SITE SUPPLEMENTAL INSTRUCTION

PROJECT: Forestside Estates
Attmar & Palleschi Drive
Brampton, ON

SITE SI NO. M-7

PURPOSE: To revise make-up air risers to suit space requirements & City Permits comments.

DRAWN MC	CHECKED LM	SCALE 1:50
DATE MAY, 2019	PROJECT 18-017	DRAWING M-27A OF -

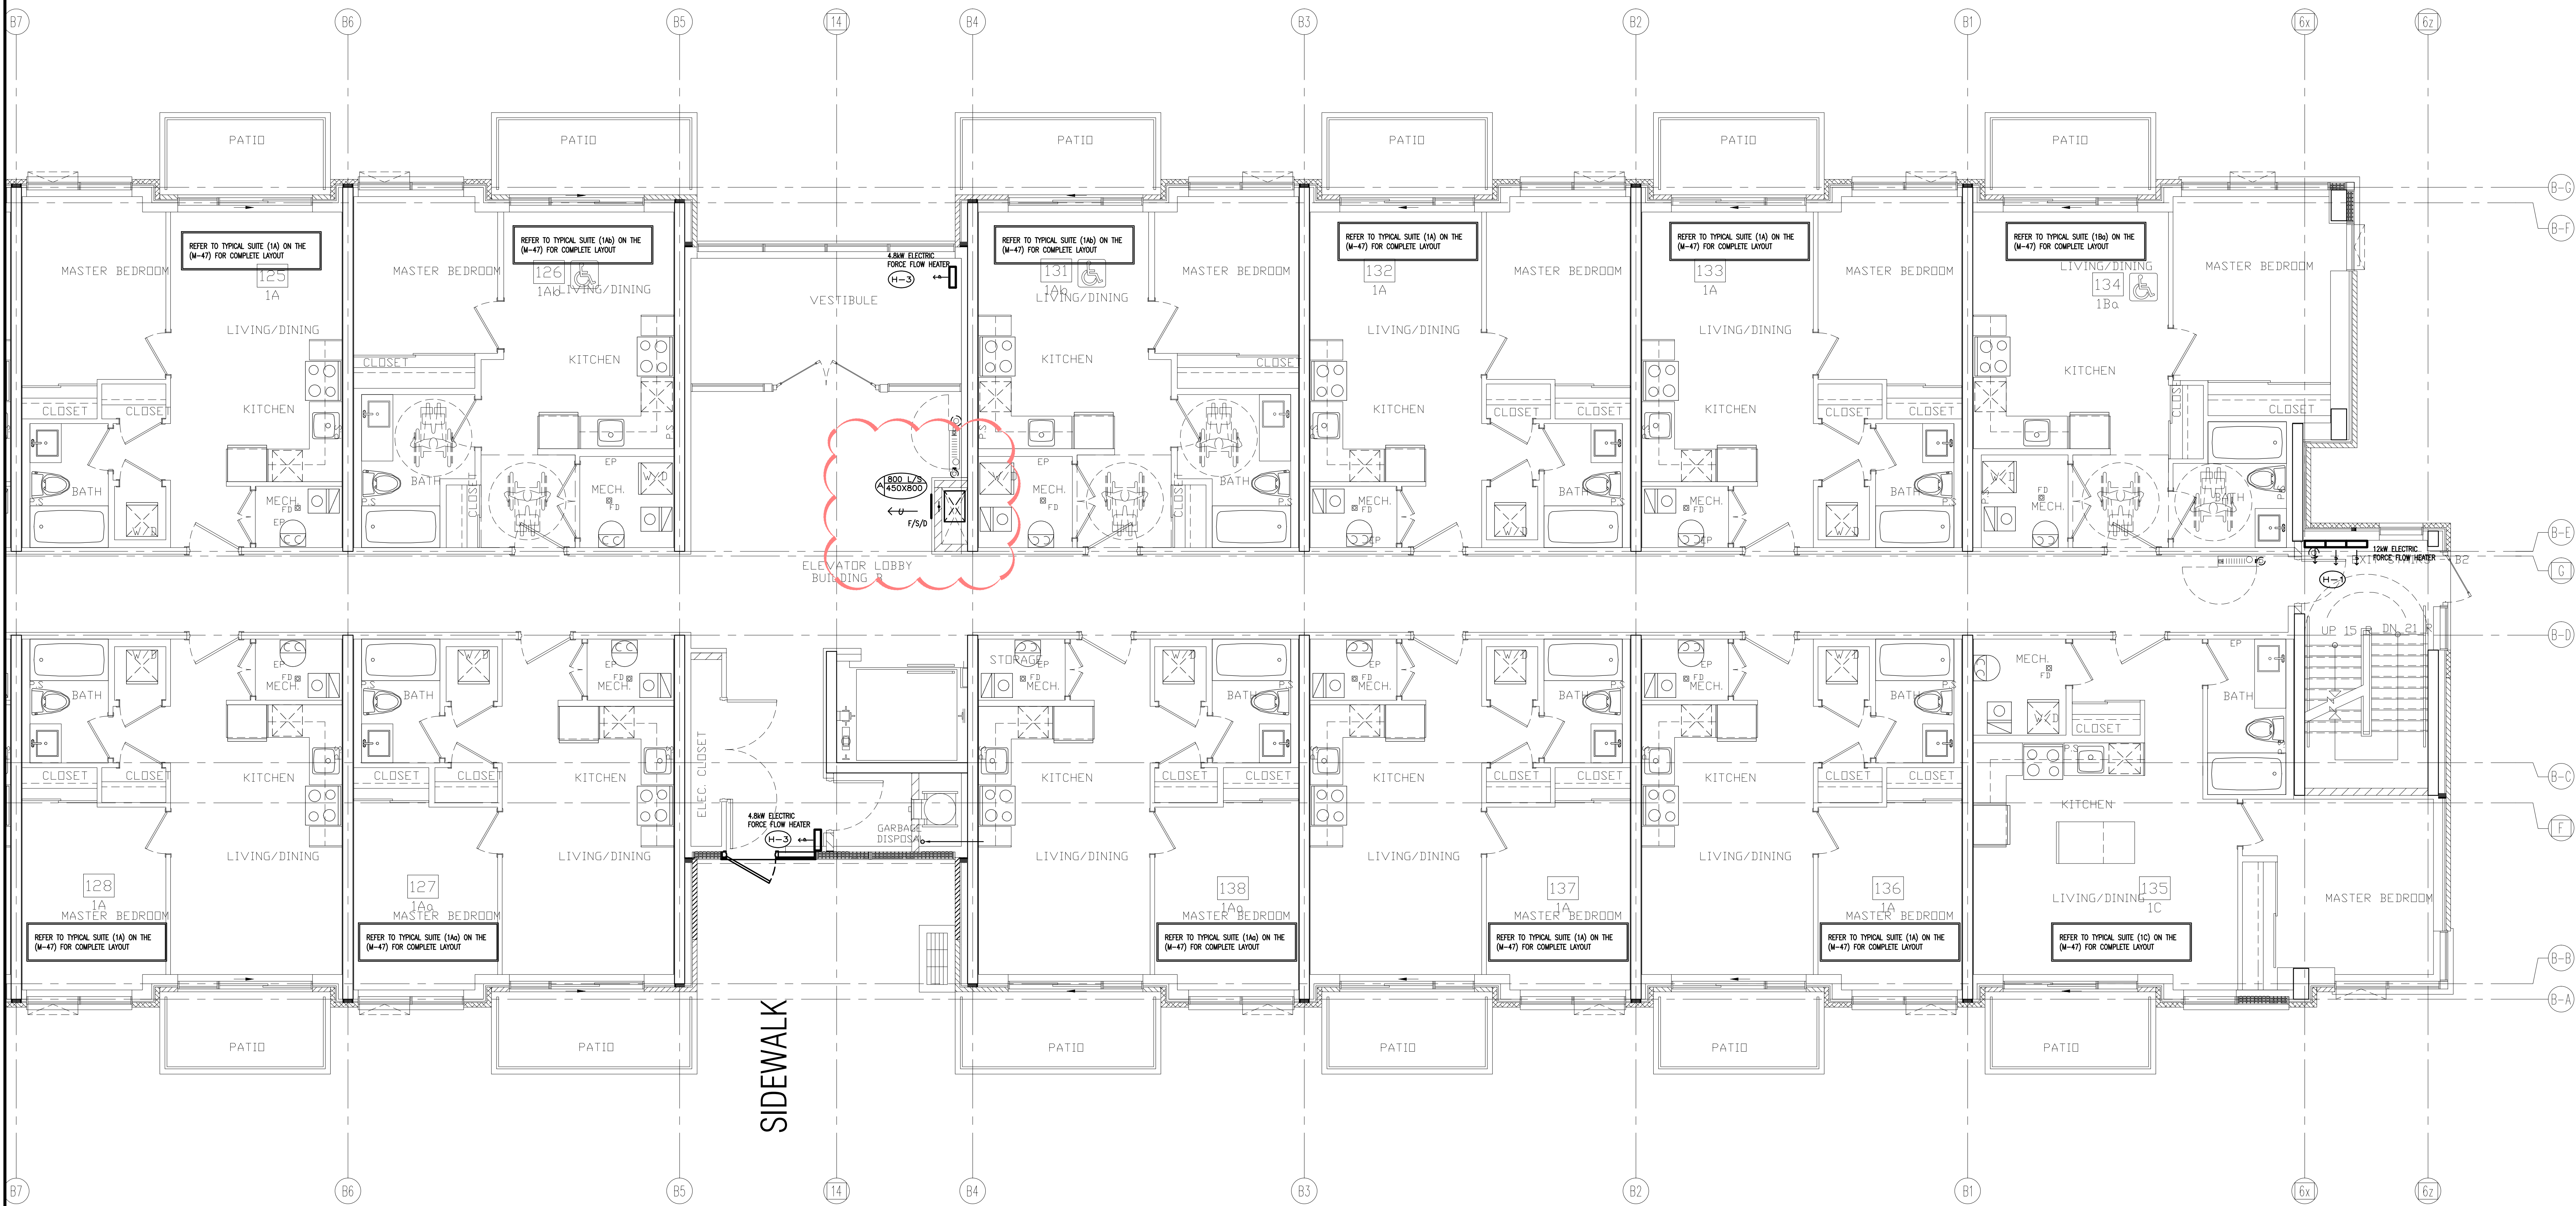
11.1 Relocate: Make-up air riser.
Locate make-up air riser 600mm.
Back from face of corridor wall (cut floor).

TITLE BLOCK 'B' 3RD FLOOR - HVAC 1		
PROJECT BRAMPTON STACKED FORESTSIDE ESTATES ATTMAR + PALLESCI DRIVE BRAMPTON, ONTARIO		
DRAWN MC	CHECKED LM	SCALE 1:50
DATE MAY, 2019	PROJECT 18-017	DRAWING M-29A OF -

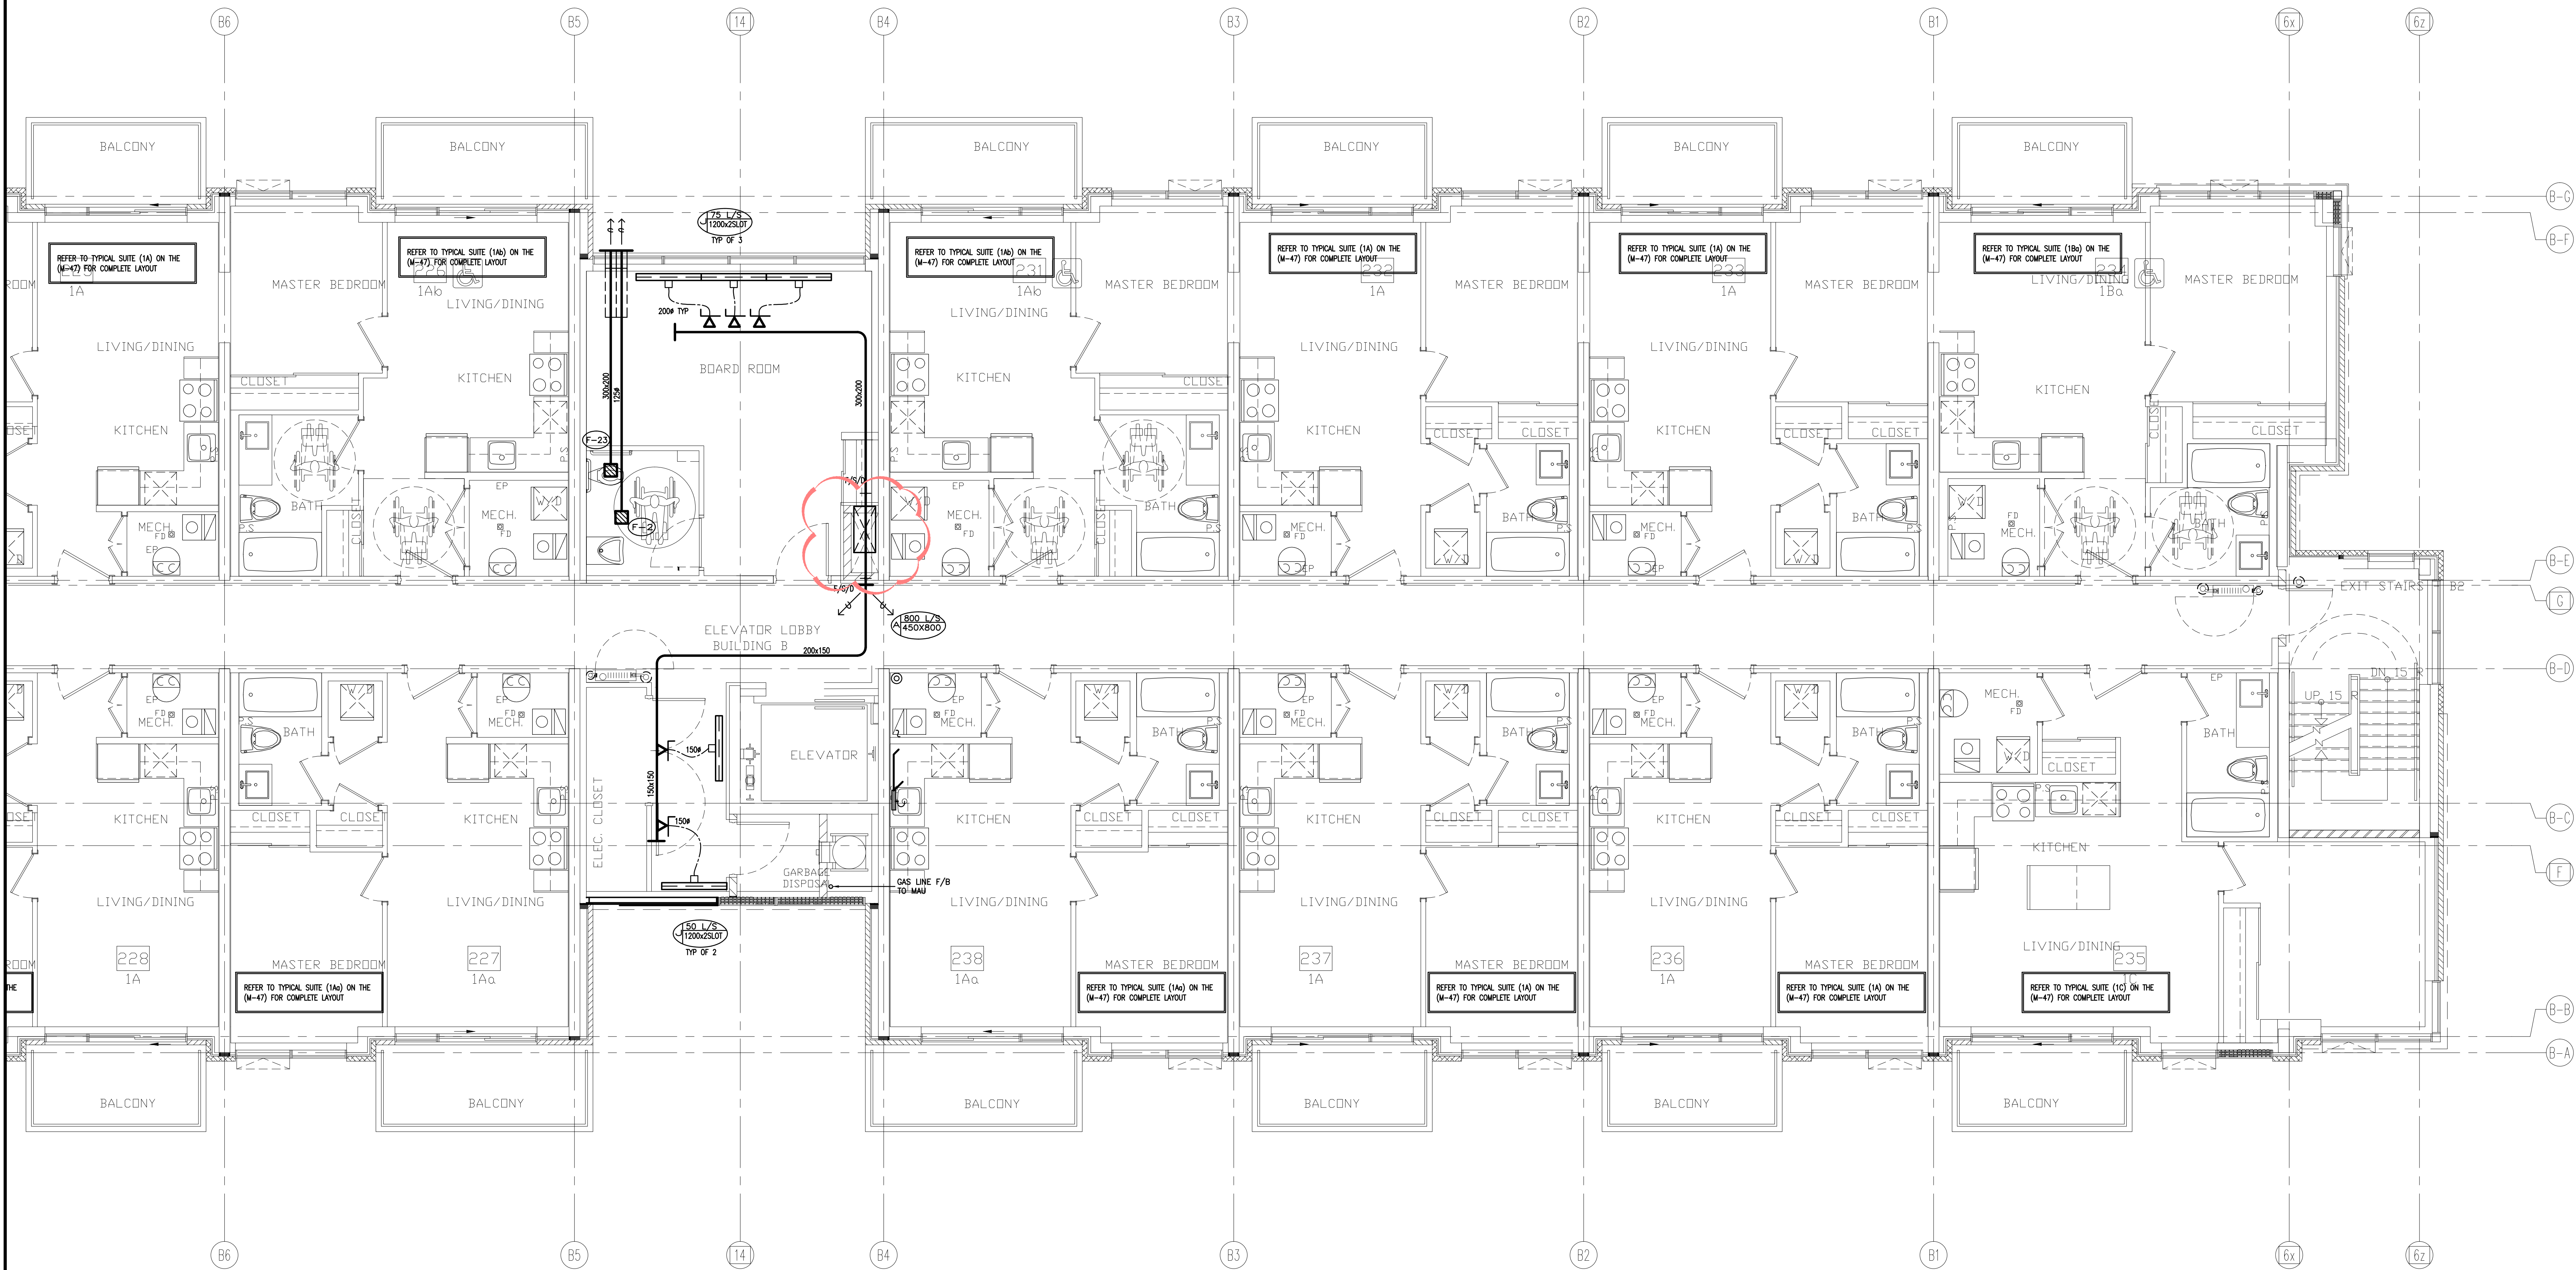
12.1 Clarify: Make-up air riser.
Locate make-up air riser 600mm.
Back from face of corridor wall (cut floor).
